Subject: Class 1 Plan Modification Determination
Transfer of Ownership and Name Change
Badger Disposal of Wisconsin, Inc.,
EPA ID# WID 988580056
FID # 241384000

**BEFORE THE STATE OF WISCONSIN
DEPARTMENT OF NATURAL RESOURCES**

**CLASS 2 LICENSE MODIFICATION
FINAL DETERMINATION**

**BADGER DISPOSAL OF WISCONSIN, INC.
EPA ID# WID988580056
FID# 241384000**

SITE PLAN
SCALE: 1" = 30'-0"

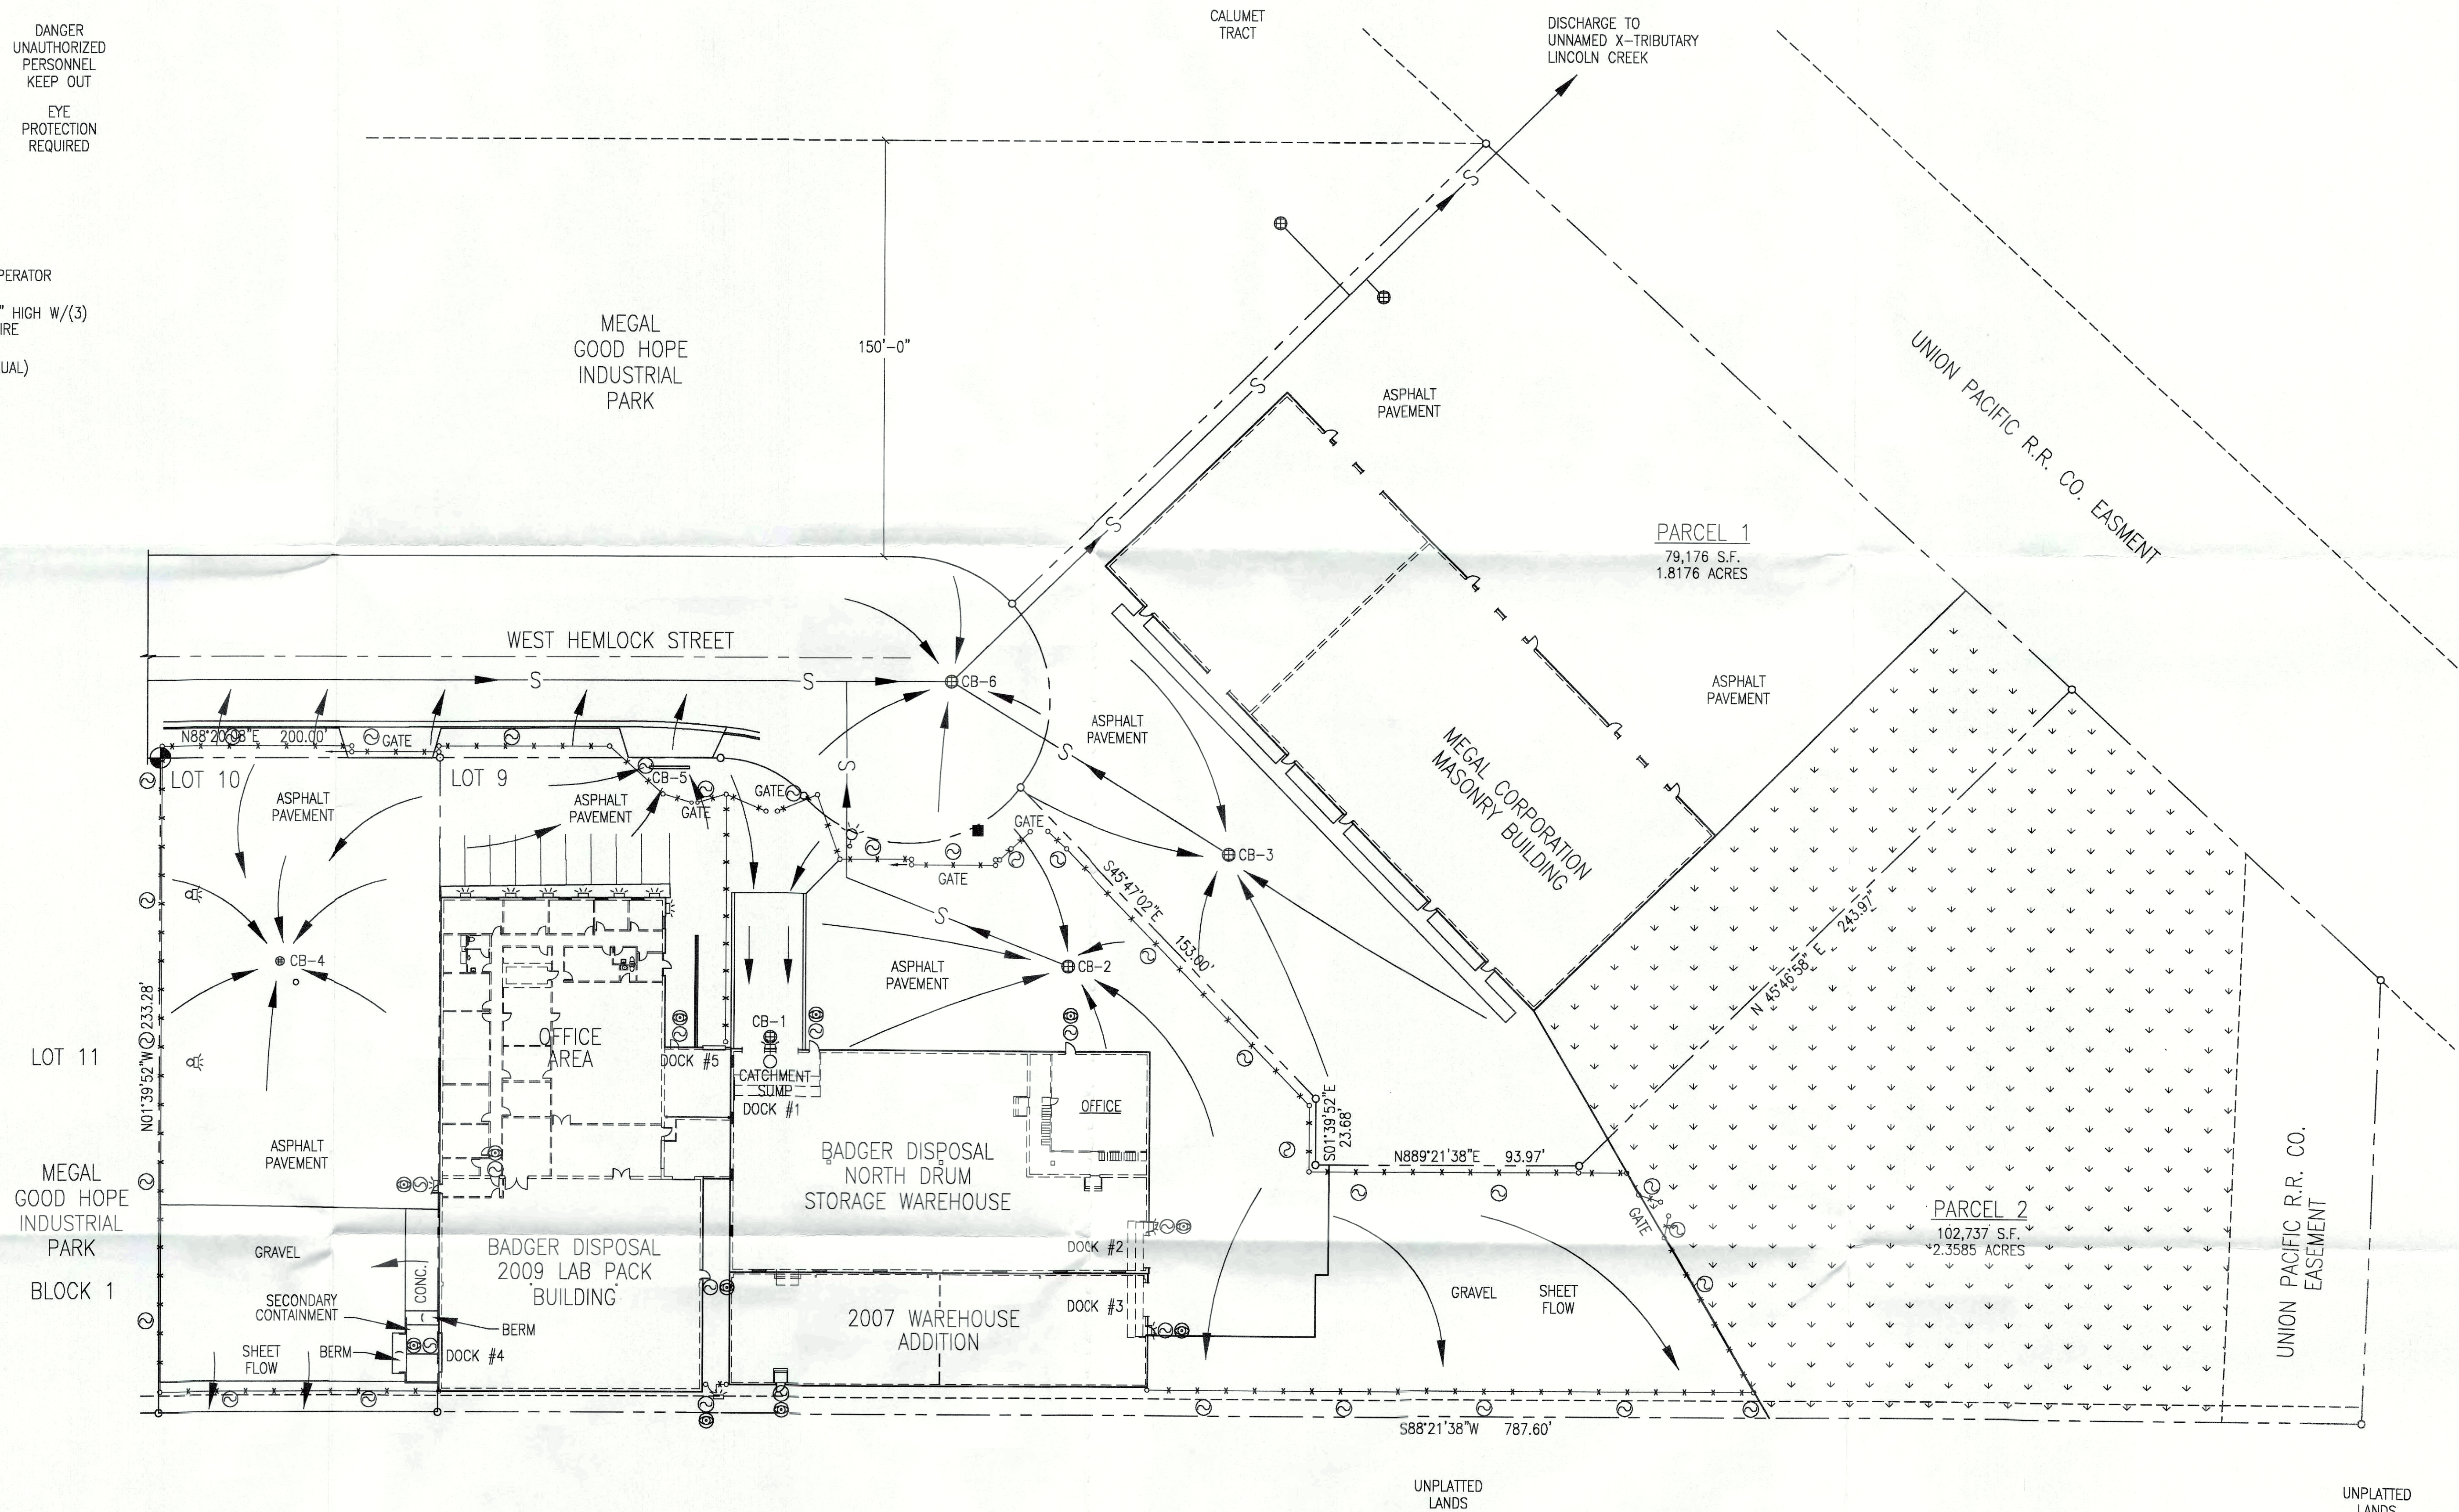
NO.	DATE	BY	REVISION
3	11/5/09	J.M.N.	ADDED SECONDARY CONTAINMENT AND RAMPS AT DOCK #4.
2	7/31/09	J.M.N.	ADDED PURCHASED PROPERTY TO WEST PER PROJECT NO. 08740
1	10/11/07	J.M.N.	ADDED 2007 WAREHOUSE ADDITION PER PROJECT NO. 07649
